Addendum No. 4

Reference: Unified State Laboratory – Module 2
Department of Public Safety
Department of Health
Department of Agriculture and Food
DFCM Project No. 13020300

Addendum #2

PROJECT NAME: Unified State Laboratory Module 2

LEVEL 2 WASTE AND VENT PLAN AREA B
1/8" = 1'-0" PW102B

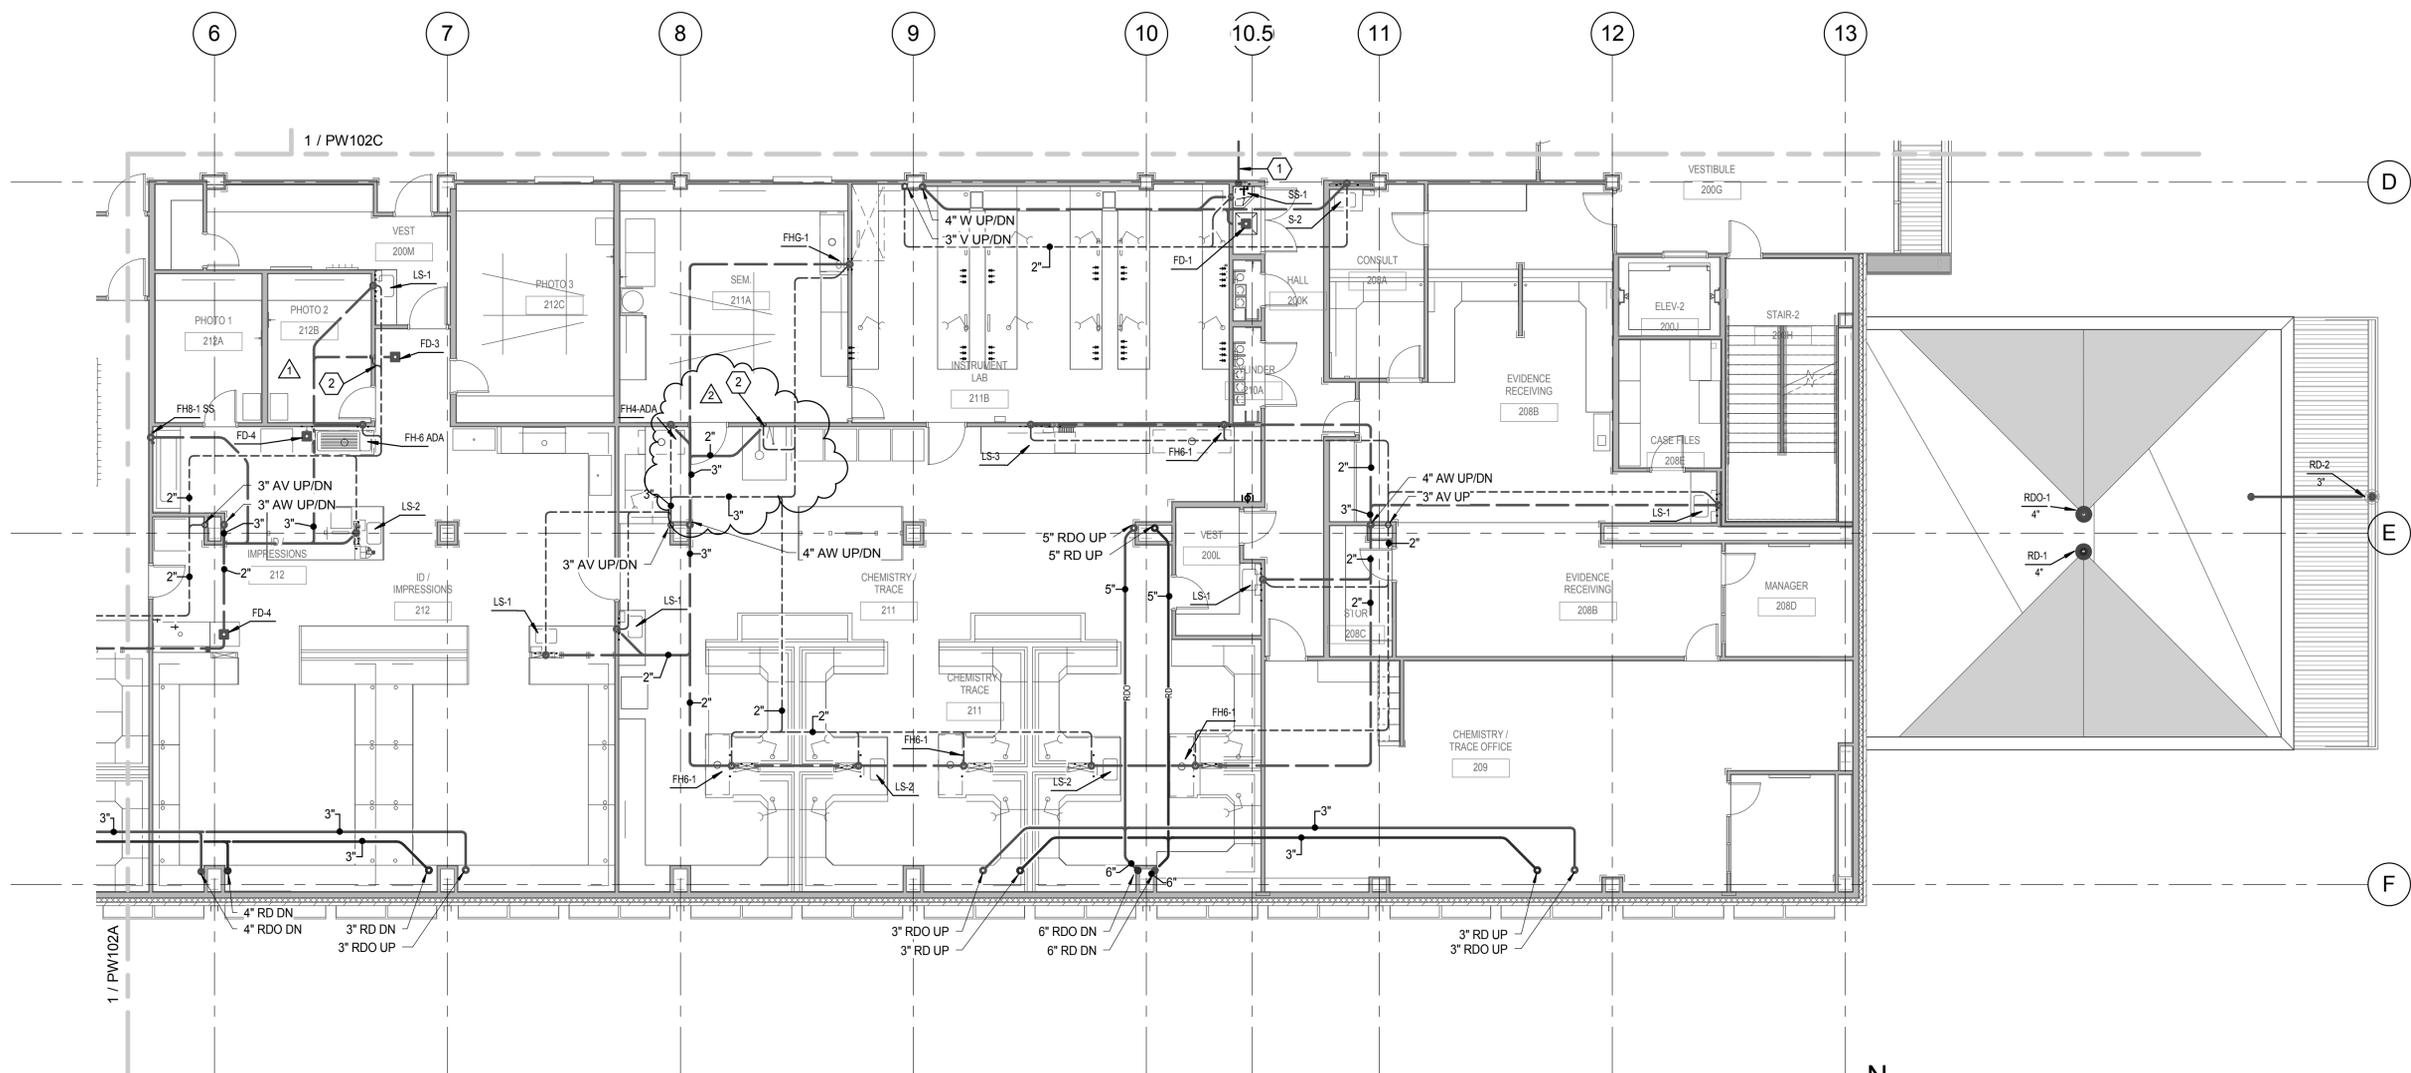
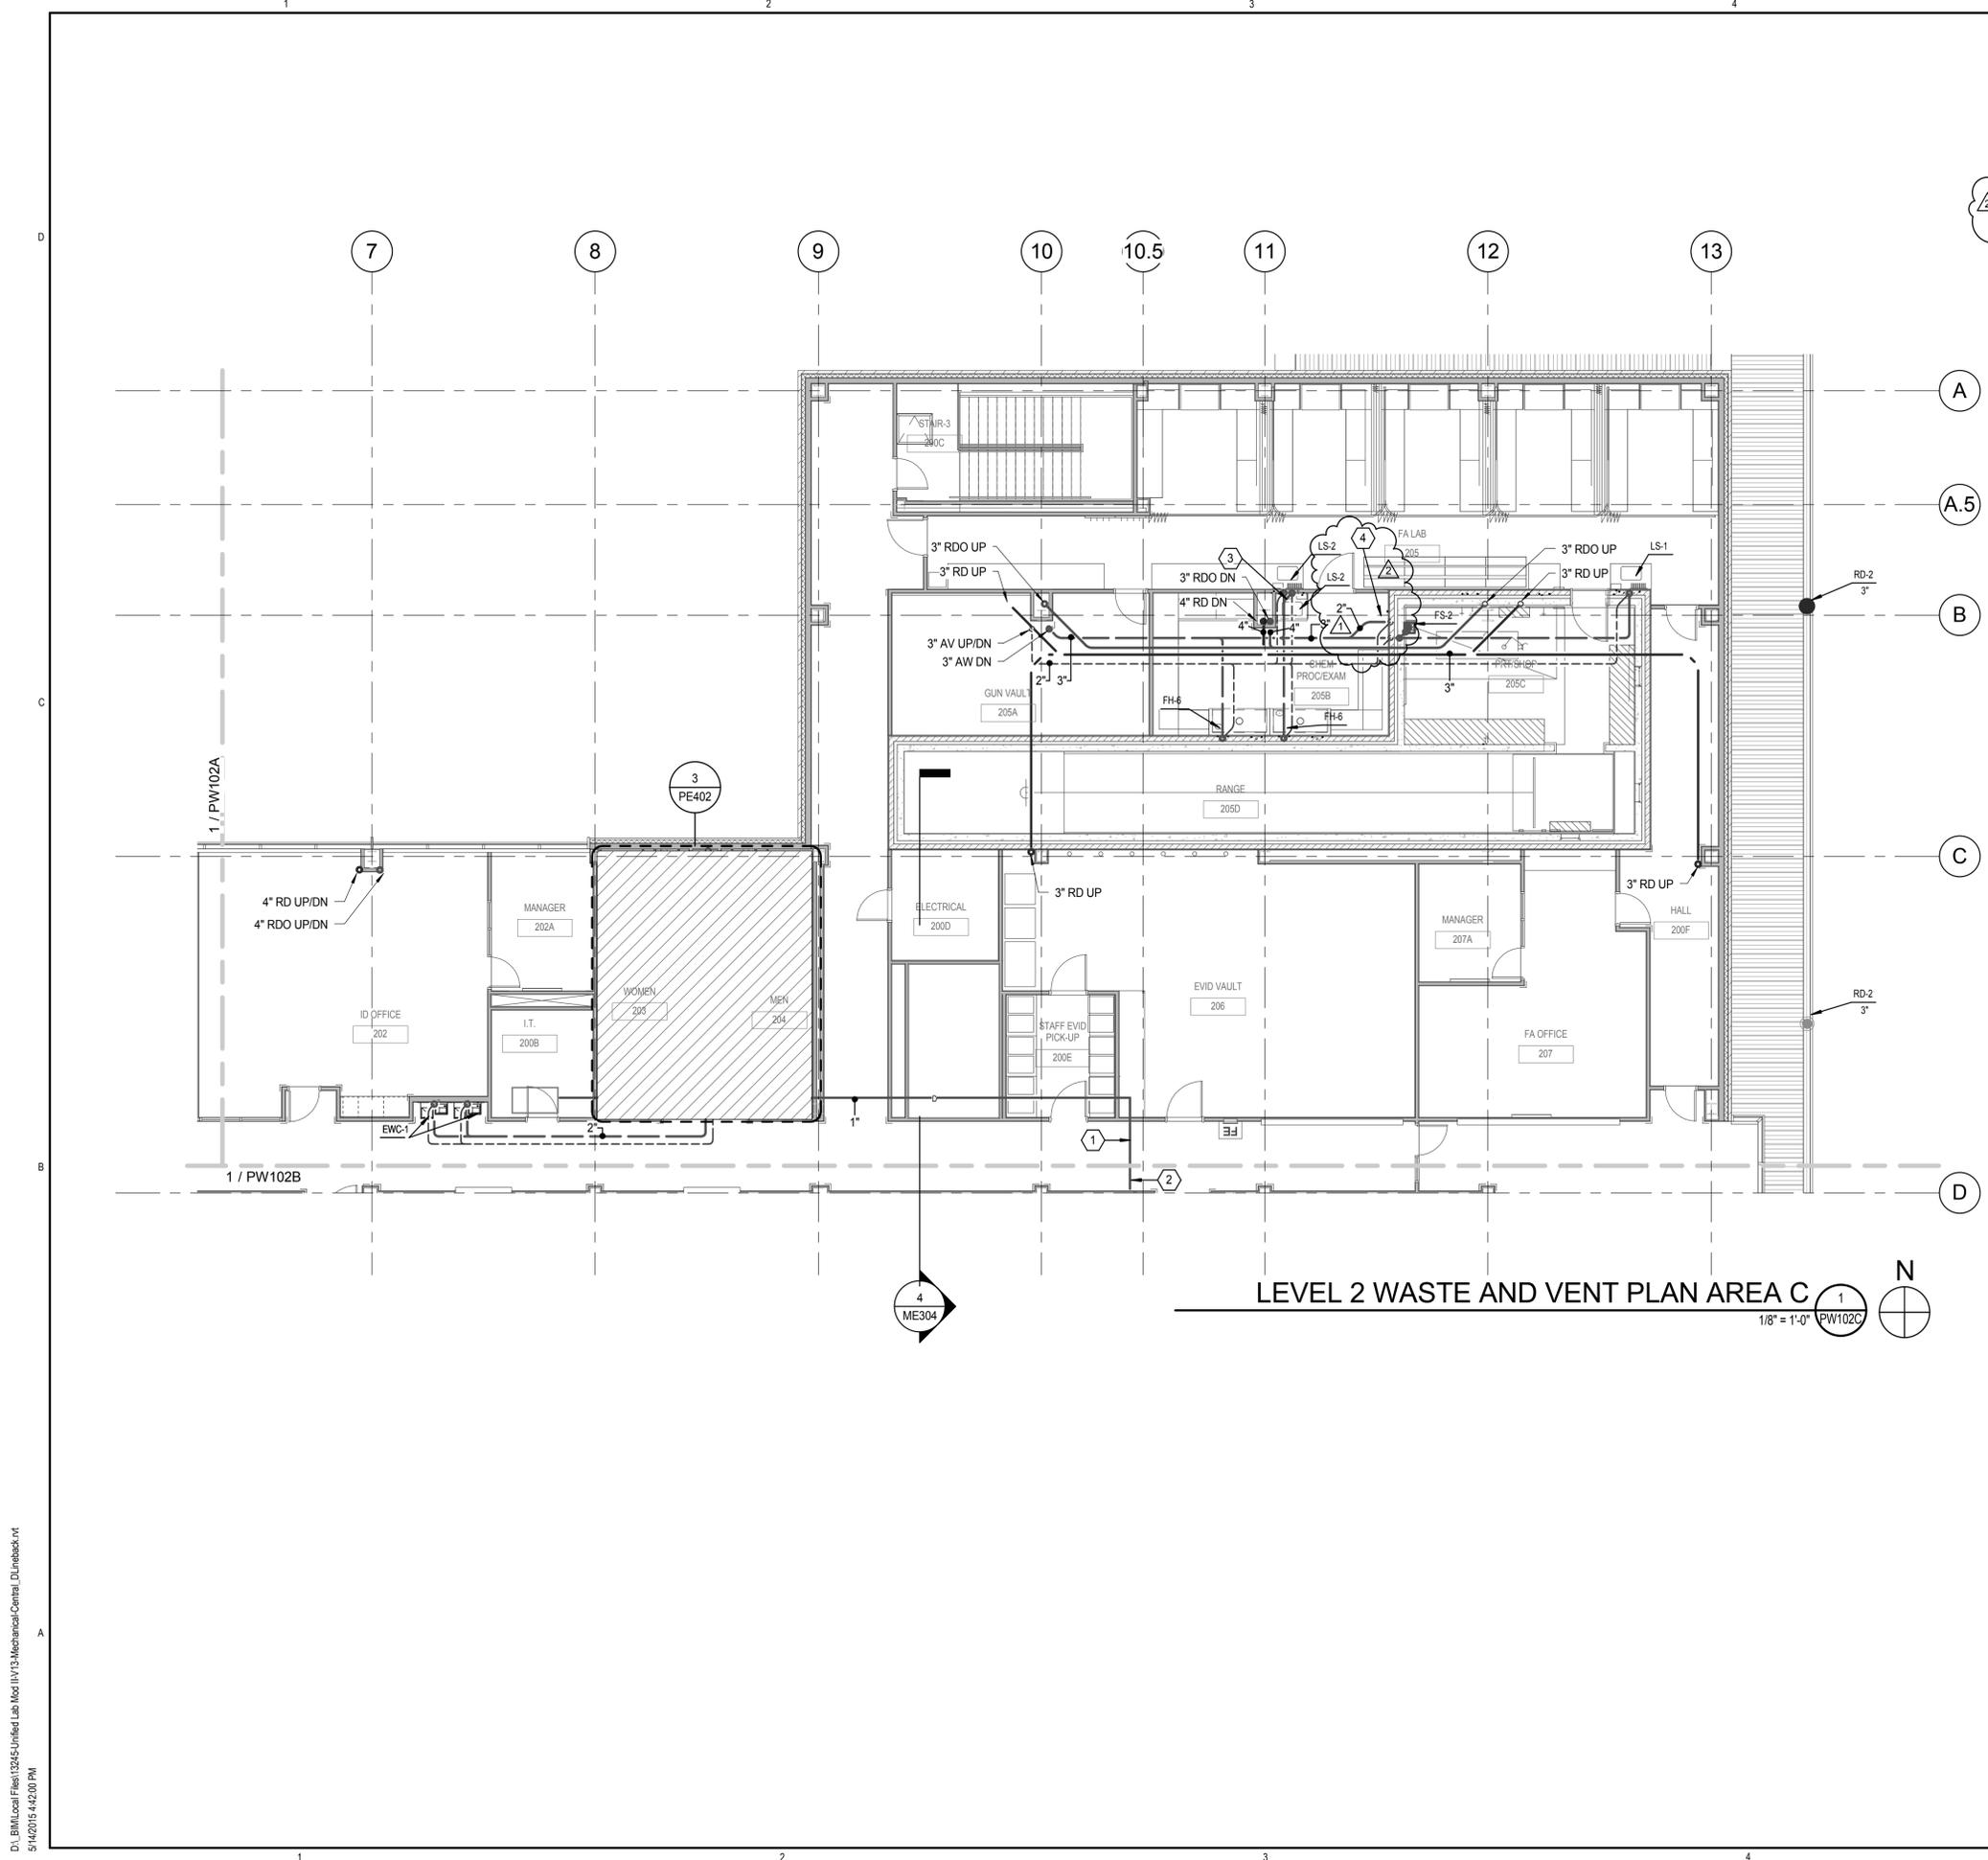
1. Add waste and vent connection and keyed note to eyewash portion of emergency wash station in Chemistry Trace-211.

PW103A

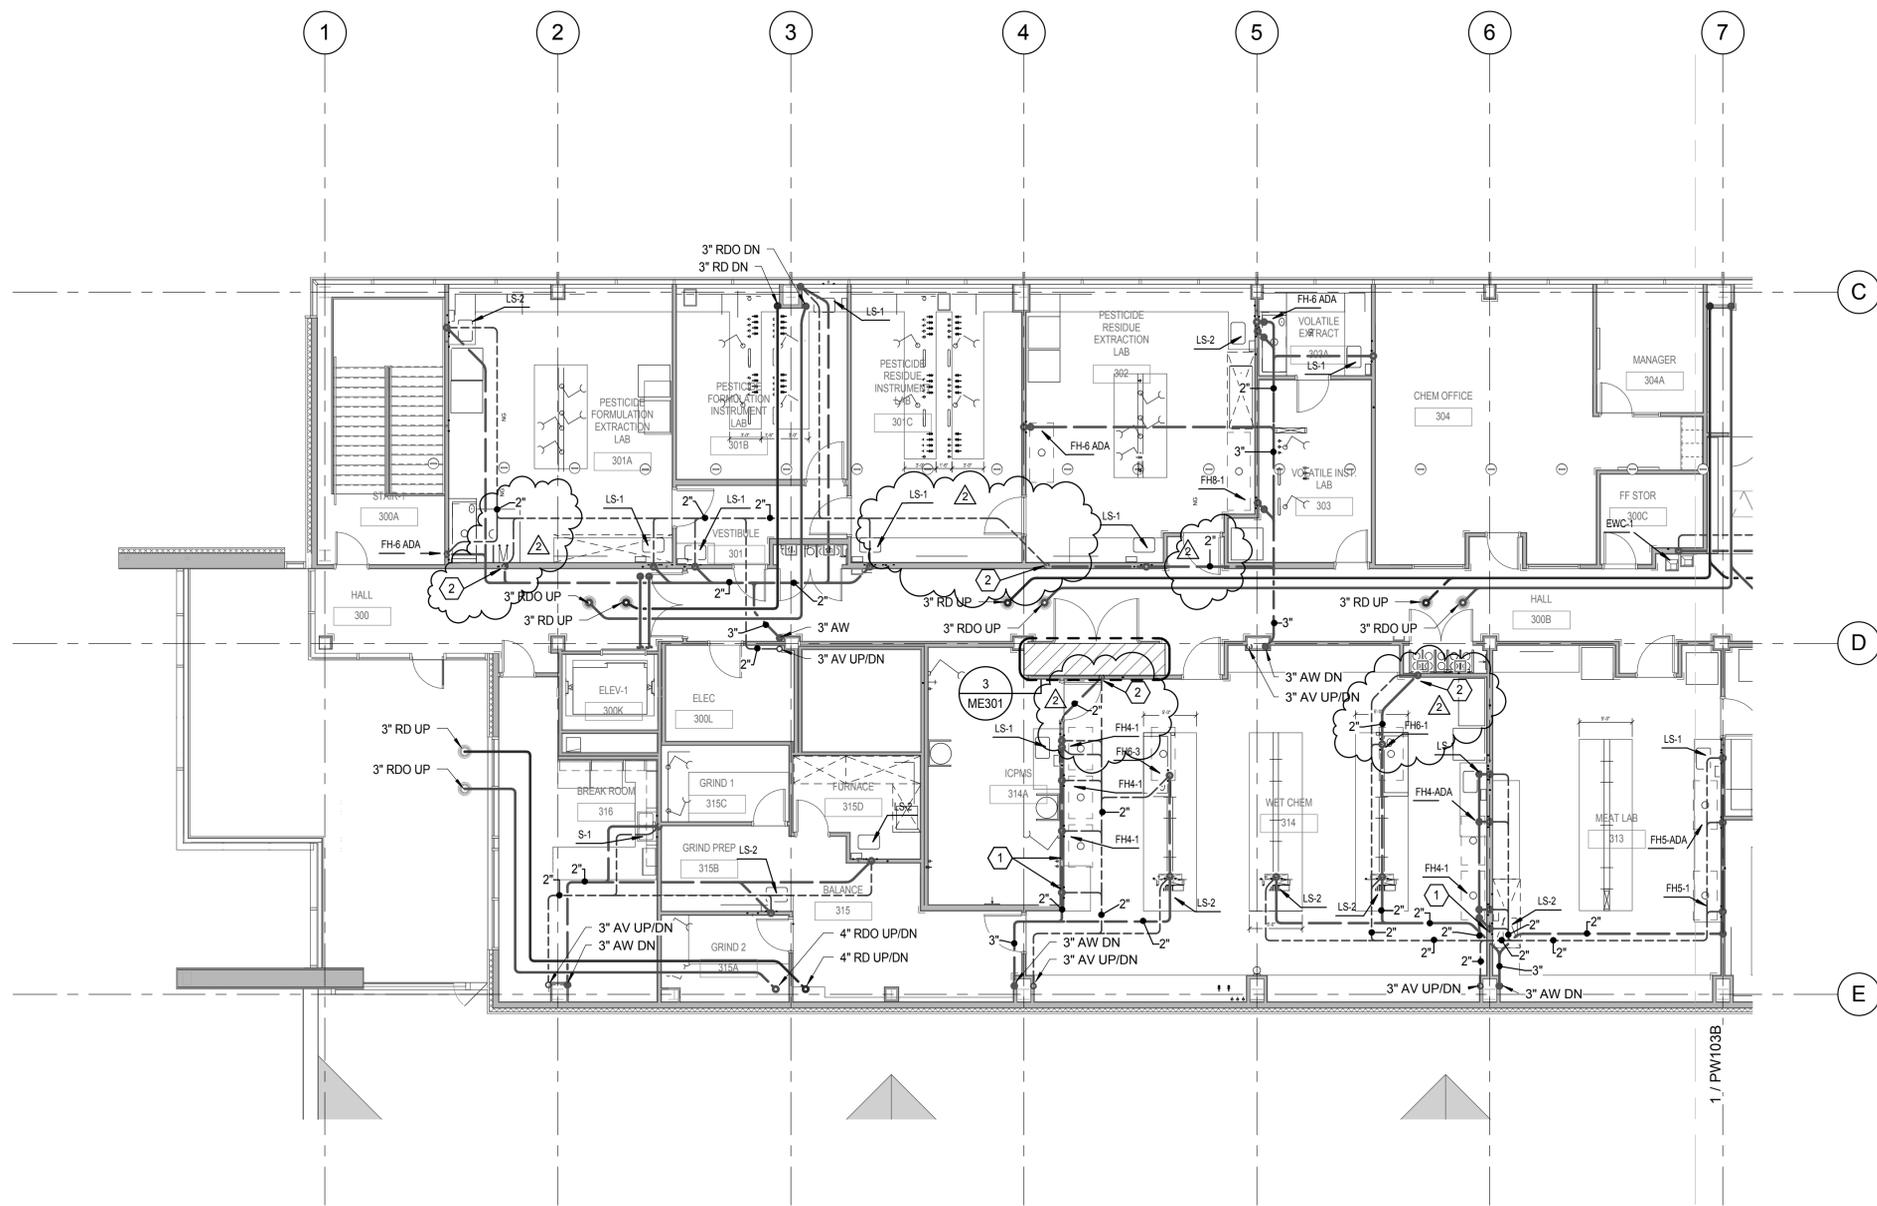
1. Add waste and vent connection and keyed note to eyewash portion of emergency wash stations in Pesticide Formulation Extraction Lab-301A, Pesticide Residue Instrument Lab-301C and Wet Chem-314
